December 21, 2015

**Re: Strata Energy Ross In Situ Recovery Project
Source Materials License SUA-1601, Docket No. 040-09091
Request to Amend License Condition 11.3**

Figure 1. Water Quality Comparison between MU1-OZ23 and Other MU1 OZ Wells

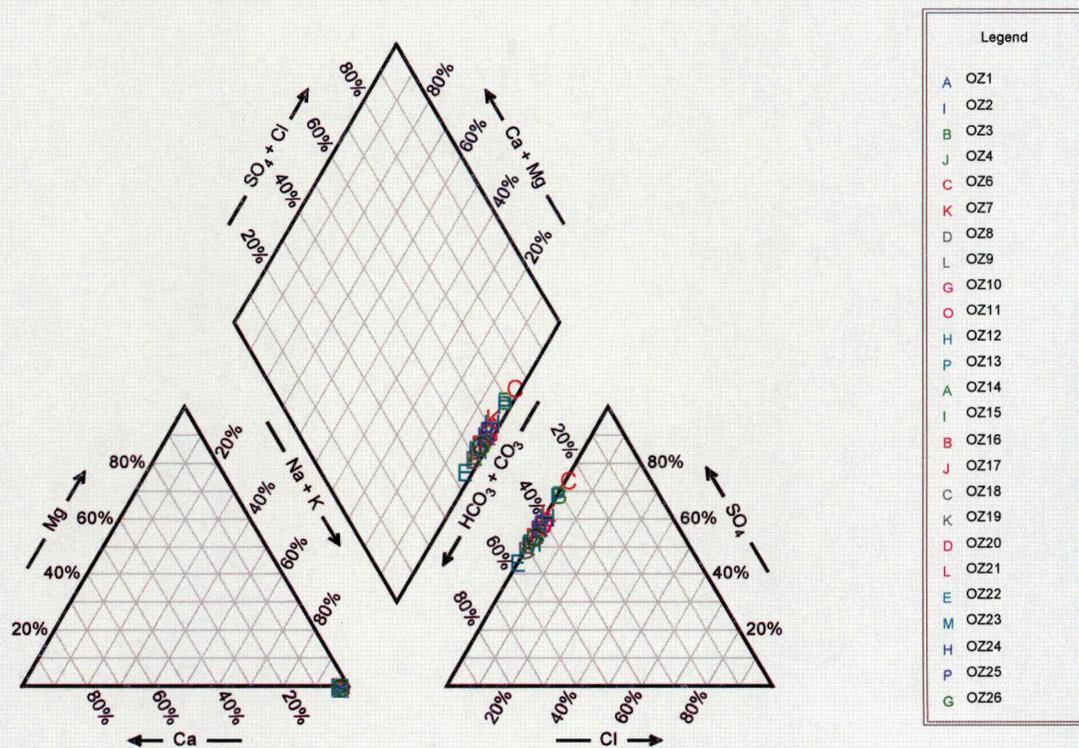
The MU1 wellfield data package evaluates groundwater quality at a hydraulically isolated well (MU1-OZ23) and demonstrates that there is not significant variability in the baseline groundwater quality at this well compared with the other OZ wells. Figure 1-3 in the MU1 wellfield data package shows the low permeability zone along the southern periphery of MU1 that was identified through aquifer testing. Well MU1-OZ23 lies south of this zone and is hydraulically isolated from the other OZ wells (i.e., it did not respond to pumping during the first aquifer test, during which a well north of the low permeability zone [MU1-OZ02] was pumped). The hydraulic isolation of MU1-OZ23 is analogous to the situation evaluated on pp. 72-73 of the SER, in which two hydraulically isolated monitoring wells in the Nubeth R&D Project had “abnormal” water quality compared to the remaining Nubeth wells. The following describes how this is not the case for MU1-OZ23. Further, the following section describes how additional evaluation of the Nubeth data shows that the hydraulically isolated Nubeth wells also had consistent water quality with that in the OZ aquifer in MU1.

Attachment 7, Table 1 and Attachment 9, Table 1 in the MU1 wellfield data package show that there are no outliers identified in any of the sample results from MU1-OZ23. This demonstrates the lack of statistical evidence that the water quality in MU1-OZ23 is different from that in the remaining OZ aquifer in MU1.

Water chemistry comparisons are provided in Figure 1 that further illustrate that the water quality in MU1-OZ23 is consistent with the remaining OZ wells. Comparisons were performed for major ions, including chloride and carbonate, which are mentioned on p. 73 of the SER as specific parameters identified as having "abnormal" concentrations in the Nubeth R&D Project. Figure 1 shows that the water quality in MU1-OZ23 is within the range of concentrations found in other MU1 OZ wells. The comparisons in Figure 1 demonstrate that the water quality in a hydraulically isolated well (MU1-OZ23) is consistent with that in the other OZ wells in MU1. All data used to prepare Figure 1 are found in Attachment 7, Table 1 of the MU1 wellfield data package.

Figure 2. Water Quality Comparison between Nubeth M2, M3 and MU1 OZ Wells

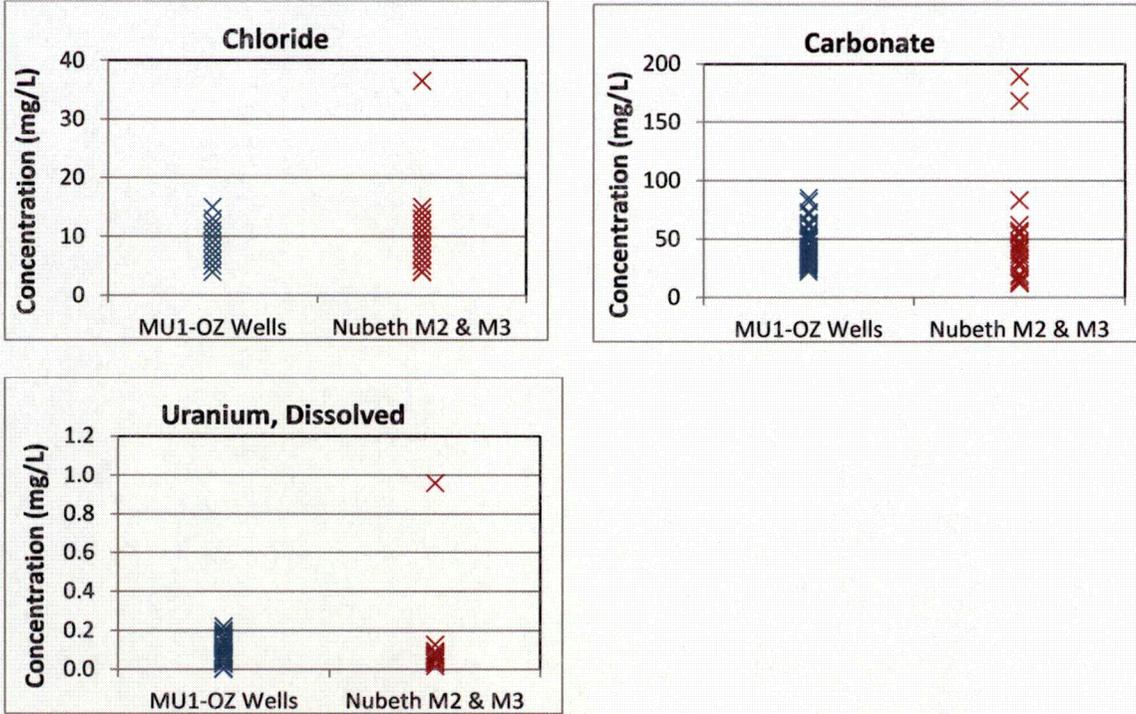
Since the data from Nubeth monitor wells M2 and M3 provides a basis for the minimum OZ well density, Strata compared the historical Nubeth data to the MU1 sampling results to see if the historical values were “abnormal” in the context of OZ aquifer natural variability across an entire mine unit. The results of the evaluation demonstrate that what appeared to be “abnormally high” values for certain constituents in M2 and M3 are actually well within the range of the MU1 OZ aquifer sampling results except for a few early samples from monitoring well M3, which are clearly not representative of the long-term historical water quality from that well.

The results in Figure 2 demonstrate that except for one high sample result each for chloride and dissolved uranium (and two for carbonate), all of the historical M2 and M3 sample results generally fall within the range of the MU1 pre-operational OZ water quality. In order to further evaluate the few data points outside of the range, Figure 3 presents time series plots of each of the three parameters for M3. This figure shows that the initial chloride, carbonate and uranium measurements in M3 are abnormally high compared to the other measurements. This is most apparent in the dissolved uranium concentration, which was over 10 times greater than the long-term average concentration in this well.

Figure 3. M3 Sampling Results Showing Abnormally High Initial Measurements

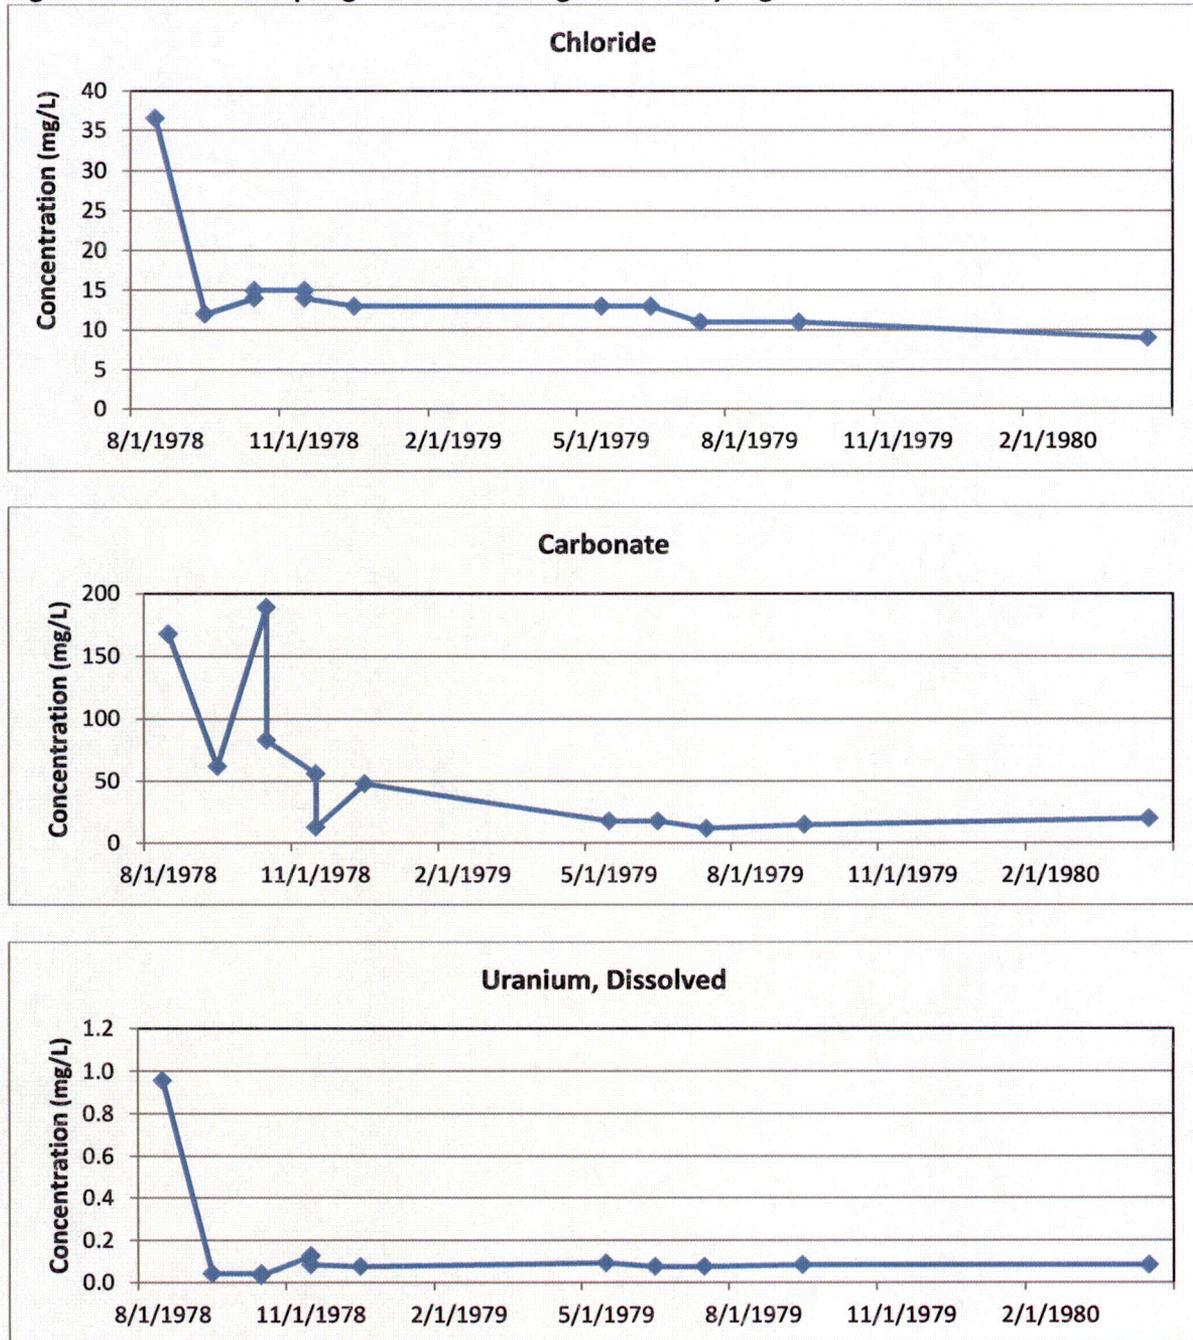
Figure 3 demonstrates that the initial one to three samples from M3 were not representative of the true groundwater quality at this location. The abnormally high values are likely attributed to incomplete well development or insufficient purging of water in the well casing prior to sample collection. In any event, such abnormally high values would be screened and removed as outliers if they were used to establish Commission-approved background in a wellfield data package. The results of this evaluation demonstrate that what were previously identified as “abnormal” constituent concentrations in the Nubeth pilot project are actually within the range of typical OZ aquifer water quality except for the initial sampling results from the M3 monitor well, which are not representative of the long-term water quality in that well. When all of the Nubeth sampling results are evaluated in the context of the scale of a full mine unit, there does not appear to be any historical evidence of anomalous water quality conditions associated with hydraulically isolated wells.
